**Amendments To The Drawings**

Application Serial No. 10/500,452  
Reply to Office Action of August 8, 2005

**Replacement Sheet of FIGS. 4-6  
(a total of one sheet of drawings)**

FIG 6

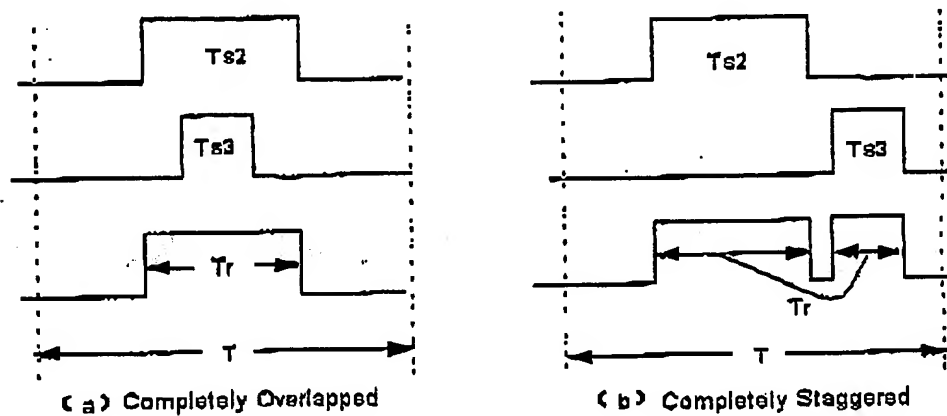
In the Office Action, the Examiner objected to the drawings as not showing every feature of the invention specified in the claims. In particular, the Examiner contends that the figures as filed do not show: the host identifying pulse width  $T_s$ ; the host releasing pulse width  $T_w$  and the feedback pulse width  $T_r$ , which are recited in claims 1, 3, 6 and 9. The Examiner also contends that the figures do not show a logic OR bus or a simple AND bus.

A revised FIG. 6 is submitted with depicts  $T_r$ . No new matter is added because  $T_r$  is fully described in the specification text. As for showing  $T_s$ , various instances of  $T_s$  are shown in FIG. 6 as filed. In particular,  $T_{s2}$  and  $T_{s3}$  are clearly shown in FIG. 6.

As for  $T_w$ , the Applicant contends that  $T_w$  is not capable of illustration as it is a pulse width time or duration that a slave module responds to. As such,  $T_w$  is analogous to a scalar used for the determination of host releasing. See for example the first full paragraph on page 9. Since  $T_w$  is not capable of being depicted in the figures yet is described in the specification, claims that recite  $T_w$  as a limitation are fully supported by the specification.

The two (2) attached drawing sheets provide a revised FIG. 6.

One of the attached sheets is annotated using a yellow highlighter to show the proposed corrections to FIG. 6. The other attached sheet is a replacement sheet.
